NVIRONMENT AND CLIMATE CHANGE CANADA (ECCC)	2
` ,	
ROWN-INDIGENOUS RELATIONS AND NORTHERN AFFAIRS CANADA (CIRNAC)	4
IVALLIQ INUIT ASSOCIATION (KIA)	20

Interested Party:	Environment and Climate Change Canada (ECCC)	Rec No.:	ECCC#1
Re:	Water Management During Closure

Interested Party:	Crown-Indigenous Relations and Northern Affairs Canada (CIRNAC)	Rec No.:	Background, Results of Review
Re:

Interested Party:	Crown-Indigenous Relations and	Rec No.:	CIRNAC#7
	Northern Affairs Canada (CIRNAC)		
Re:	Figure A.2

Agnico Eagle January 2017 - Figure A.2 – Year : 2019 – Whale Tail Pit Waste Rock Management Plan

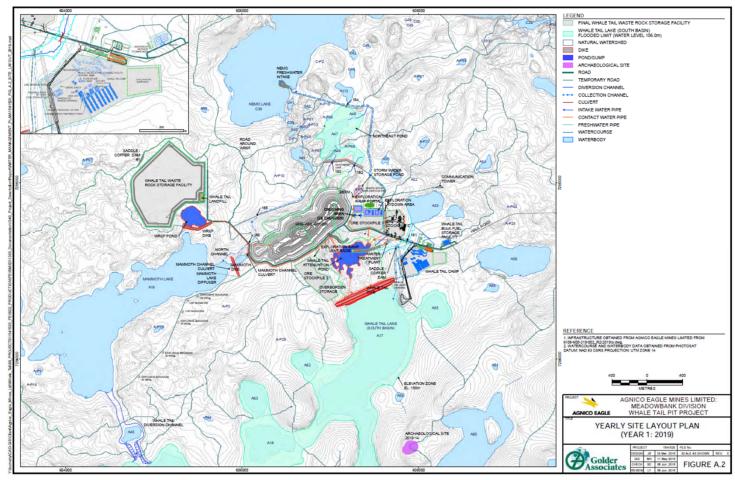
The Figure indicates that the North Basin of Whale Tail Lake has been de-watered but water levels in the South Basin have not increased accordingly.

The figure should be modified as appropriate.

Agnico Eagle does not agree with this recommendation. The Figure is correct and shows increased South Basin water levels.
